PLAN COMMISSION STAFF REPORT

Tuesday, March 10, 2020 – 6:00 p.m.

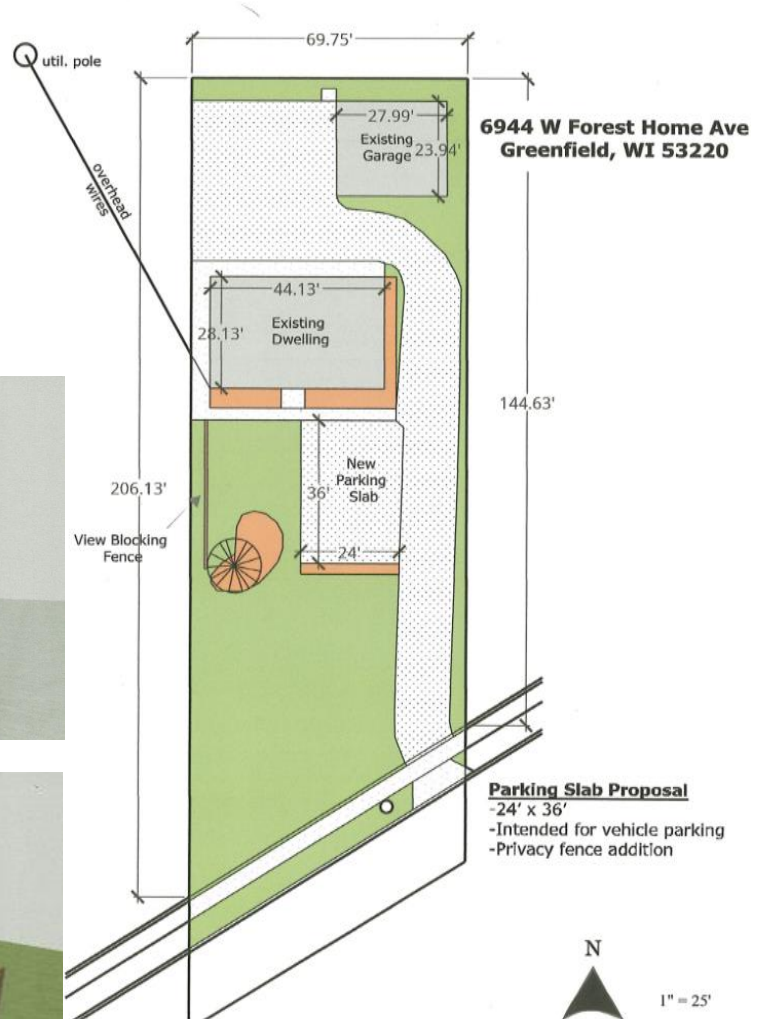
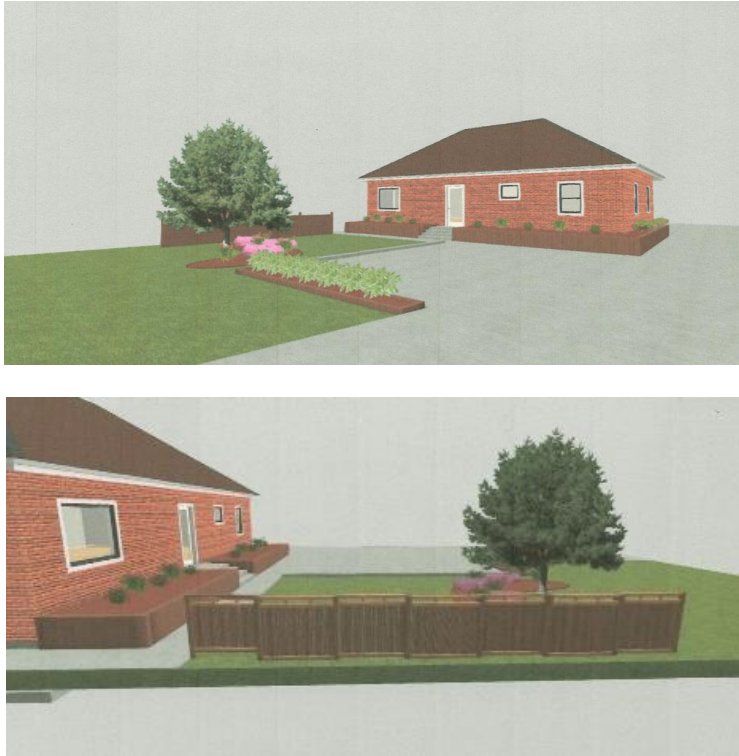
The applicant seeks to add an asphalt off-street parking slab to make the property more useable for potential tenants and clients. Exterior site improvements include the addition of a 24' x 36' parking slab at the front of the building connecting the driveway and sidewalk to the front entrance. New curb would be added to the western portion of the slab to prevent vehicles from parking on the grass. A proposed 36' long wooden fence would be installed along the western property line to screen headlights from the neighboring residential property. The applicant proposes adding new landscaping is

adjacent to the southern portion of the slab to screen the parking slab from the right of way although no formal landscape plan or plant species count has been received by staff.

Recommendation: Without having an approved user for the property, staff cannot determine the amount of parking required onsite. Therefore, staff does not have a recommendation to provide at this time. If Plan Commission recommends approval of the site and architectural plans, staff recommends the following conditions be satisfied prior to release of permits associated with the project:

1. Revised site plan with parking lot striping, including applicable ADA-compliant spaces, consistent with requirements in the Zoning Code.
 2. A landscape plan submitted to Community Development Division with landscaping species and quantities, to be approved by the City Forester.
5. **Site, Landscaping, and Architectural Plans for BioLife Plasma Services, a proposed plasma collection center, to be located at 7801 W. Layton Ave., submitted by Eric Draskowski, d/b/a Excel Engineering Inc., and Ben Westra, d/b/a JCW Development, LLC. (Tax Key No. 616-8993-000)**

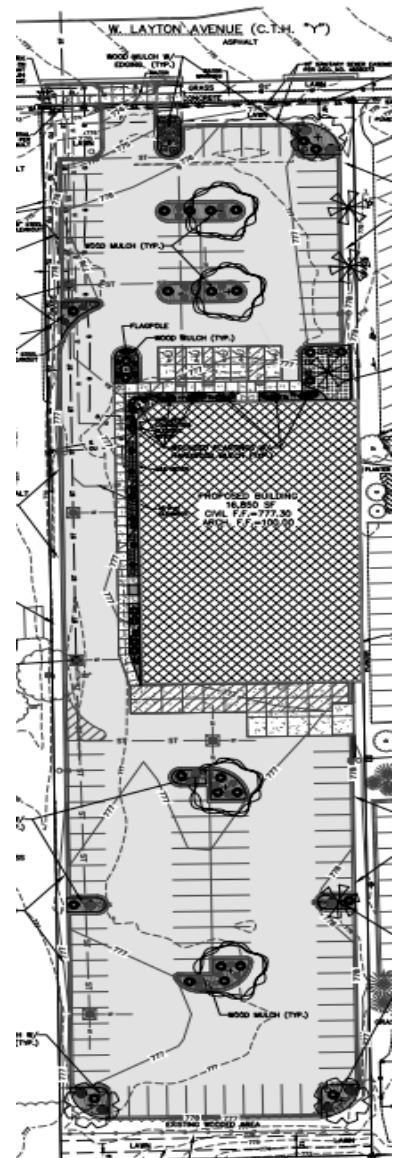
Proposed site improvements include removal of the south half of the existing vacant building (current building size is slightly more than 30,000 sq. ft., and will be reduced to 16,850 sq. ft.) and general parking lot improvements.

The existing pavement on site will be resurfaced and striped to meet the parking demands of the future owner. The lot will be rearranged to provide maneuvering area for full-size semi deliveries. The eastern parking lot drive entrance to W. Layton Ave. will be eliminated, per the request of City staff, and the western driveway entrance will be shifted a bit east. Parking space layout has been maximized to achieve as many stalls as possible to try and meet the visitor parking demand. Pedestrian walkway access will be provided along the west building wall to allow donors and employees a safe route to the front of the building at the main entrance on the north side.

Impervious area will be reduced with the proposed site improvements. Landscaping will be updated along the street side, new landscape islands will be constructed in the front and rear parking lots, and foundation plantings will be added along the front and western side of the building. A four-sided split face block refuse enclosure with a personnel door will be constructed in the rear of the building. The existing wood fence along the south property line will be removed, as it is in poor condition, and replaced with a new six-foot board-on-board wood fence. All landscaping species/quantity changes recommended by the City Forester will be provided to the architect/engineer.

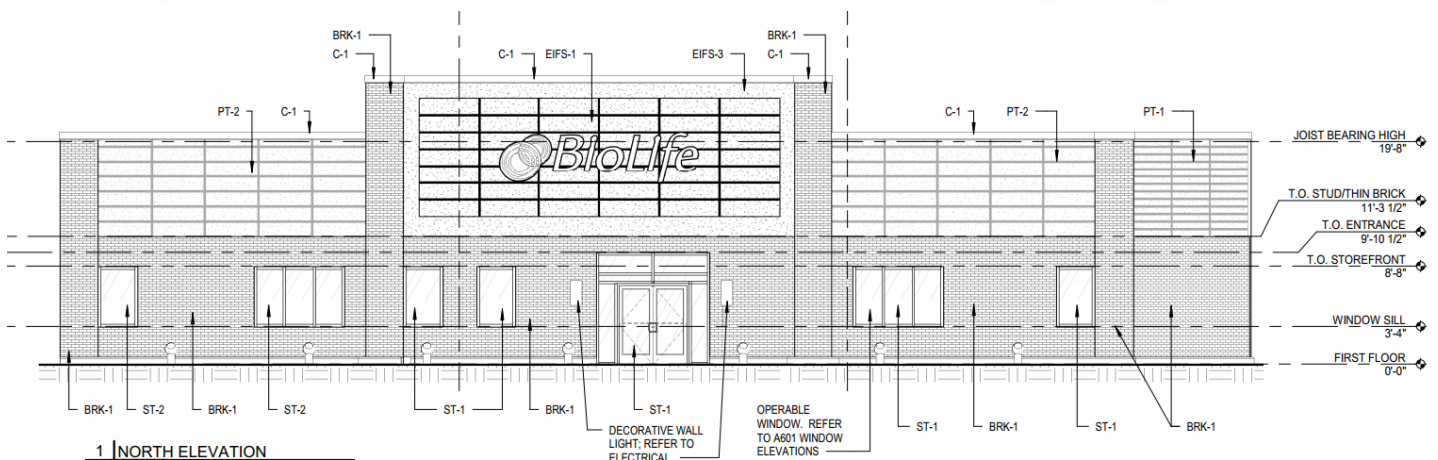
Architecturally, the applicant is proposing a different façade than what was first presented in December 2019. It has been communicated that the December façade is a template for new construction projects, and this is a retrofit. Staff has worked with the applicant and architect on modifications to the newly-proposed façade. Staff recommends further improvements, which will likely be discussed at the Plan Commission meeting.

The proposed front façade removes the triangle-shaped parapet wall entrance to the former Golf Galaxy store and incorporates a flattened horizontal parapet wall entrance. The existing EIFS building will undergo a new front façade look with thin-set brick veneer at the base, the addition of operable aluminum storefront windows and some spandrel glass windows, a new aluminum storefront building entrance door, prefinished metal coping at the roofline, and painted scored EIFS on the top half of the building. There are four (4) narrow vertical columns of brick veneer stretching from the base of the building to the roofline, two (2) located at the corners of the front façade and two (2) forming the sides of the parapet wall. The front will also include a louvered metal canopy above the entrance door.

Staff asked the applicant to consider modifications to add horizontal variety to break up monotony, some sort of depth variation along the front entrance, color variations in the painting of large/expansive walls, different materials for the backdrop of the sign, etc. Below are some pictures of retrofit projects that included a variety of colors, materials, angles, etc. that were provided to the applicant as examples.

Staff recommends, at a minimum, the following architectural modifications:

1. Addition of concrete cast window sills for architectural articulation.
2. A variety of brick colors to add horizontal variation in the brick veneer.
3. The addition of vertical columns of brick veneer along the front façade.

4. Fully-operating canopies (not louvered—a louvered canopy does not protect people from the weather elements) with awning cables at the front building entrance, above the rear service door and above the side service door.

5. A smaller amount of EIFS used along the front façade parapet wall portion, behind the wall sign.
6. Full use of brick veneer along the angled wall that connects the north and western facades.

7. The addition of a concrete cast sill (if structurally capable) along the entire west wall façade differentiating the base from the middle, where the paint color changes from EIFS-3 to EIFS4.

8. The use of a variety of paint colors along the back south wall.
